Comments Requested on a Notice of Proposed Rule Making for the Modification of Class D Airspace & Establishment of Class E Airspace at San Bernardino International Airport (SBD)

Background- Summary of Airspace Change Proposal - FAA’s July 2, 2024 , Memorandum, Subject: Revised Airspace Review – SBD

Redlands Airport Association Assessment of the Airspace Change

Existing Airspace @ SBD & REI

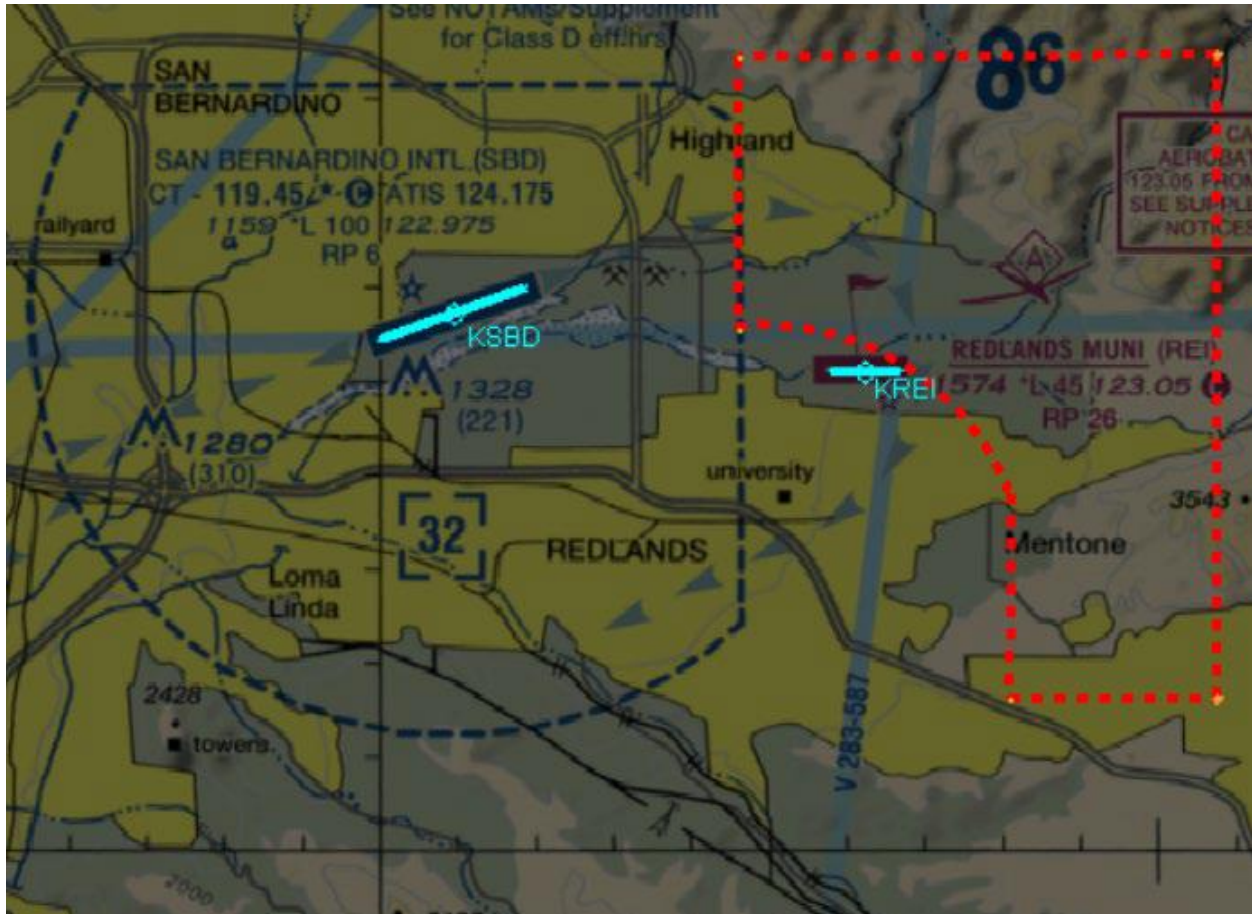
-The published TPA at REI is 2503'. That provides less than 100' separation from the floor of the newly proposed Class D shelf. This may lead to airspace incursions or REI traffic flying at a lower pattern altitude.

Proposed SBD Class E4 Extension to the Class D

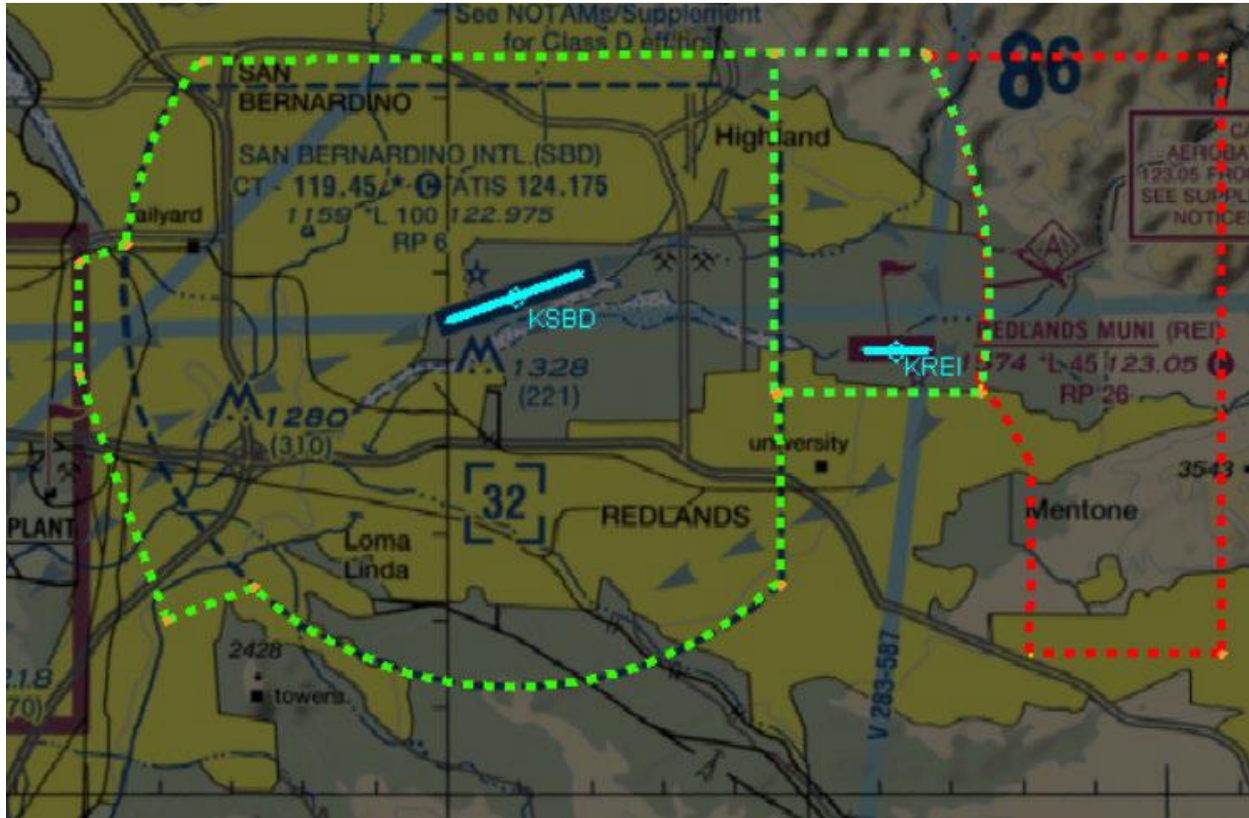
-The new E4 surface airspace designated as an extension of the Class D will be off limits to ultralight aircraft and paragliders. (See [14 CFR 103.17](#)). There are at least a ½ dozen ultralight aircraft based at REI. Although they can take off and turn southbound to remain in Class G airspace it would be difficult for them to fly a left-hand traffic pattern to land on runway 26 with the E4 Airspace abutting the northeast corner of REI's runway. It's not clear how and if REI could obtain a waiver to allow the continued operation of 103 aircraft based at REI.

- The new E4 surface airspace would impose a 3-mile visibility and 500 below 1,000 above and 2,000 horizontal foot clearance-from-clouds requirement on VFR aircraft as compared to 1 mile (day) and clear of clouds requirement for Class G airspace. The loss of the class G airspace to the north and east of REI's runway does create some operating restrictions for REI operators that may have had need to use the Class G (day) VFR visibility and cloud clearance requirements. REI does not have an FAA approved weather source, so will operators at REI need to use reported SBD weather to determine VFR visibility in the Class E4 airspace? Visibility between both airports can vary due to elevation differences. During marine layer conditions REI will become VFR prior to SBD. This condition may lead to pilots operating at REI prior to SBD reporting VFR.
